**IN RESPECT OF THE APPEAL AGAINST THE DECISION OF
HERTFORDSHIRE COUNTY COUNCIL FOR THE DEVELOPMENT
OF
LAND AT HATFIELD AERODROME, OFF HATFIELD ROAD,
HATFIELD, HERTFORDSHIRE**

**PLANNING INSPECTORATE REF: APP/M1900/W/24/3346607
LOCAL PLANNING AUTHORITY REF: PL/0232/21**

**Paper submitted by former Rule 6 parties now third parties
at the request of the Planning Inspector**

Hydrology

Brett drawing number 009:

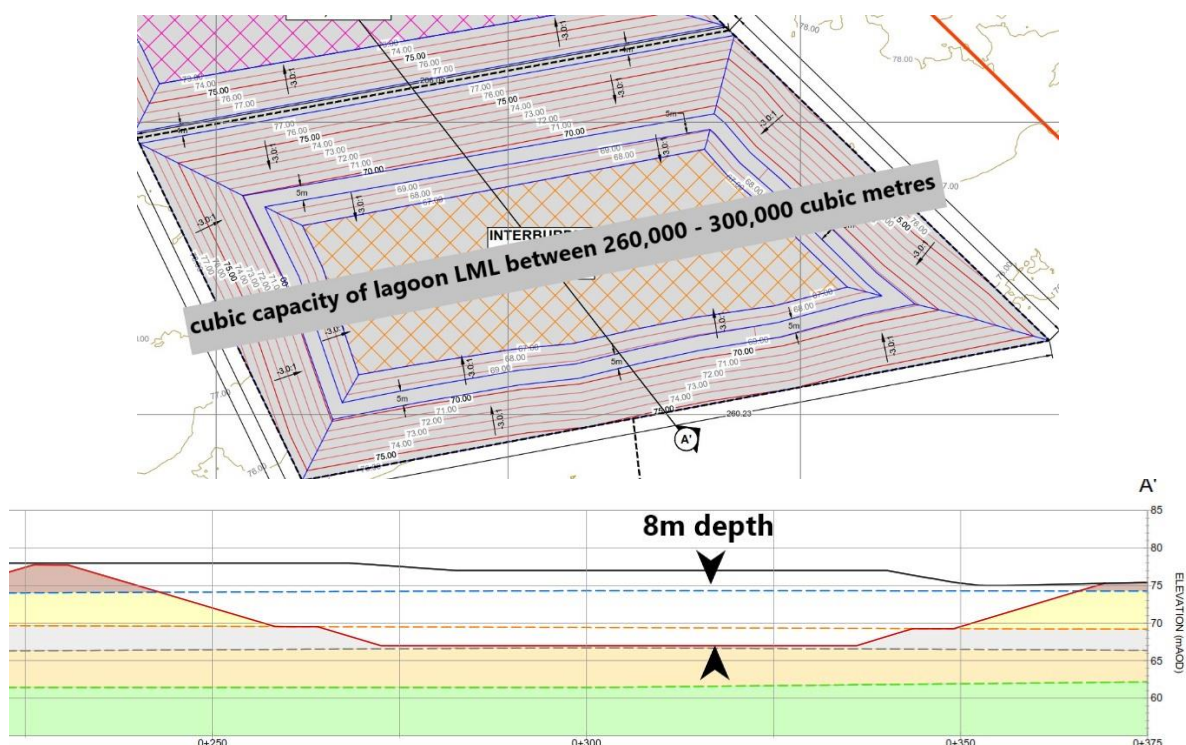
The above diagram taken from drawing 009 defines the depth and size of the LML. From measurements we have calculated the volume of the LML to be between 260,000 and 300,000 cubic metres, this is three times the volume of the UML.

The request for detail on the construction and water management of the lagoons is very limited. The LML is excavated down to the bottom of the interburden and opened up to expose the top of the LMH and lower aquifer, as this is a confined aquifer the base will quickly fill with water forming a lake of water * that is hydrologically connected to the chalk. The unnecessary operation is a risky business as cross contamination could allow the contaminate bromate to leak into the whole water system.

The planning application proposes that there should be two lagoons but now that there should be no pumping of groundwater from the lower mineral horizon as agreed at the last inquiry, it is unclear why there is still a second lagoon in the plan.

This operation is a high-risk strategy, a second lagoon connected to the chalk is not necessary as water from the extraction is channeled back into the same workings. If LML lagoon is proved to be unnecessary it would be classified as being an inappropriate development.

Borehole data showing bromate exceeding the stated concentration between 2013-2019

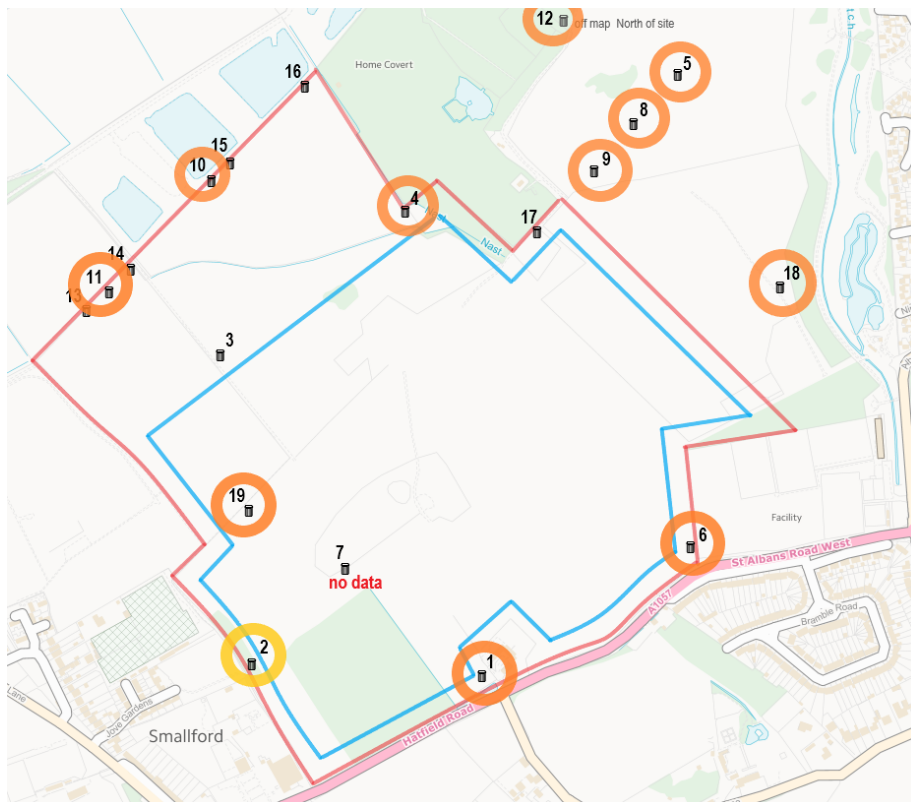
At present the only boreholes monitoring the gap between know bromate contamination in the N.E sector are BH104 and BH106, this leaves a gap of 790 metres. **BH104** data shows bromate detected over **2 µg/l** from 2019 to 2021. **BH106** shows a sporadic **7.4** in August 2019 but classified on SLR drawing as ND = non-detected.

Borehole BH108 is outside the site but shown as ND on SLR map

borehole have levels at or above 0.5 µg/l, for example 19 (BHG in dig site) had 2.4 µg/l in Oct 2015.

A wide gap exists between BH104 and BH106 and this area is vulnerable to inclusion of a drift into the site. New boreholes BH303 and BH304 have yet to be installed and therefore the argument "bromate plume east of the site and its absence on the mineral extraction area" cannot be proved.

- 2) Bromide chart and borehole location.

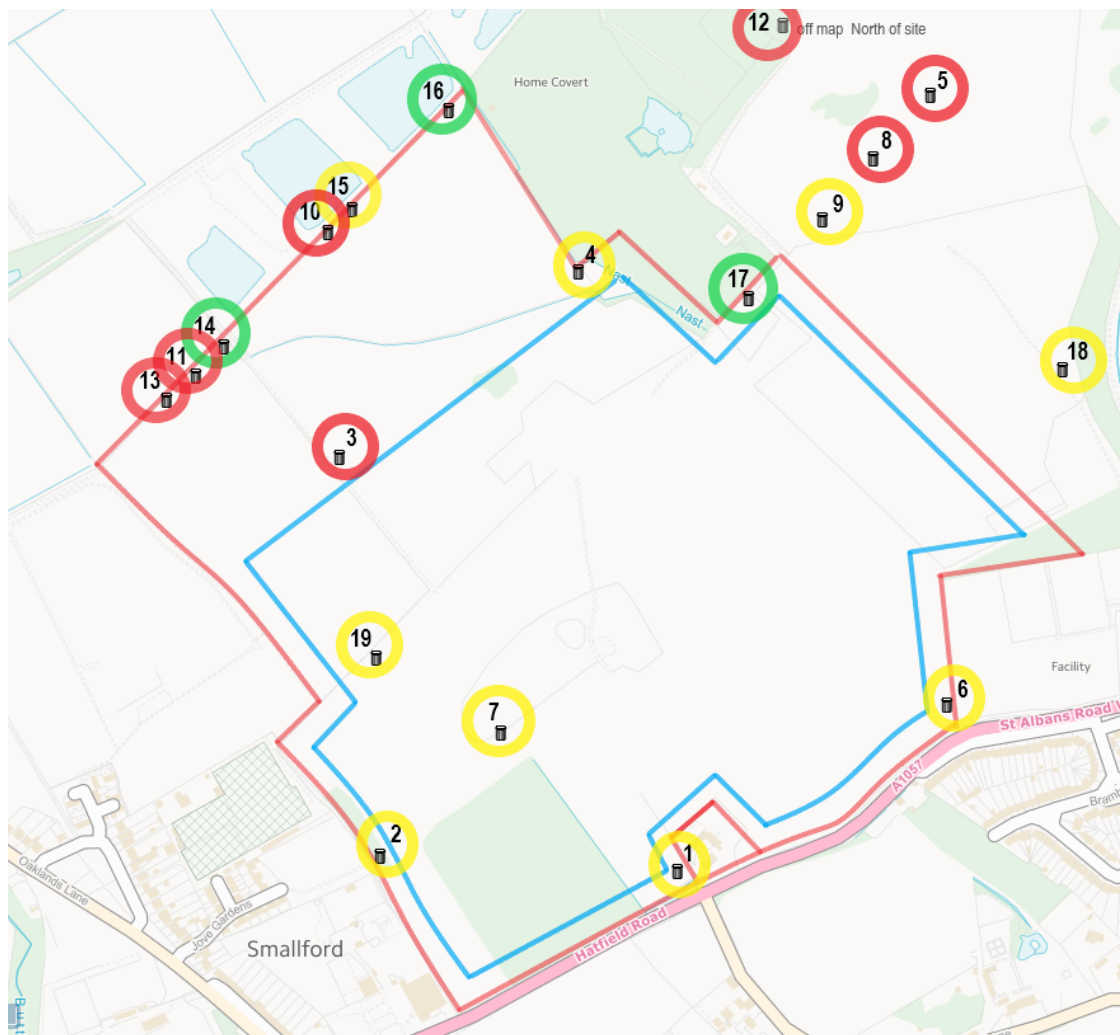
The map clearly shows that the bromide readings are above the recommended planning inspector levels (above 125µg/l) ON THE ACTUAL DIG SITE (within the blue line) see boreholes 7 and 19

The map also shows that the levels are astronomical around the dig site and within the perimeter of the quarry site, in particular Borehole 3 (right on the dig site perimeter) is 1049µg/l and borehole 11 is a massive 2280µg/l.

The data available shows that bromide is actually present in concerning levels on the dig site and that therefore given the correlation between bromide and bromate there is a strong argument to say that bromate is also present. There are clearly insufficient boreholes and associated data on the actual dig site to prove that there is no bromate present. This is a high-risk strategy.

BH103 showing chalk and LMH:

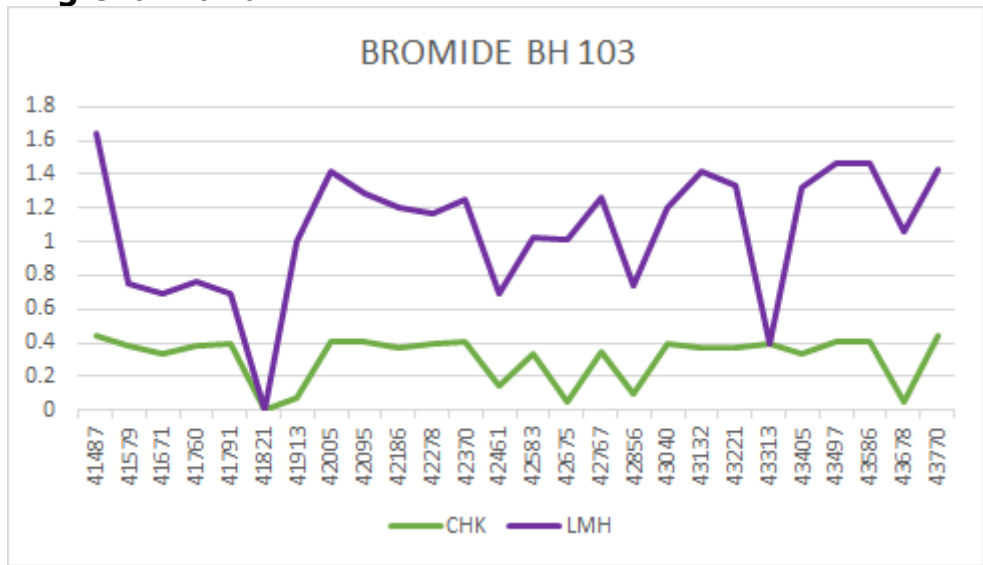
BH103 is on the borders of the plant site and dig area, it is not near any road salts or effluent from the Cemex workings but shows significant high levels of bromide – we can only assume from the original spillage in Sandridge.
